## DEVELOPMENT APPLICATION ASSESSMENT REPORT

| <b>Application Number:</b> | DA2023/0617 |

| <b>Land to be developed (Address):</b>    | Lot 6 DP 9585, 24 Angle Street BALGOWLAH NSW 2093<br>Lot 7 DP 9585, 22 Angle Street BALGOWLAH NSW 2093 |
| <b>Proposed Development:</b>              | Demolition works and construction of a Residential Flat Building                                       |

**Figure 1 - Applicants depiction of Height Non-compliance**

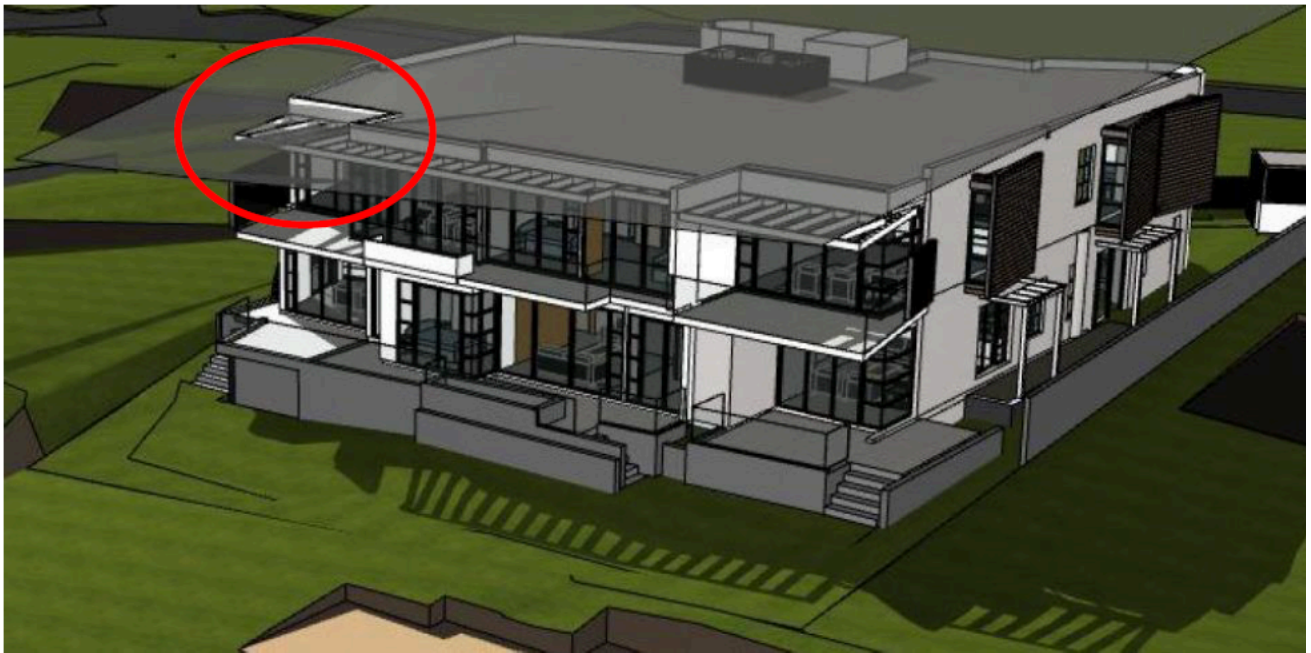
On the basis that the proposal is assessed as being inconsistent with the objectives of the height of buildings development standard as discussed below, and is inconsistent with the Objects of the EPA Act, 1979 [namely (c) and (g)], the Applicant's written request has not adequately demonstrated that there are sufficient environmental planning grounds to justify contravening the development standard for building height as required by Clause 4.6 (3)(b).
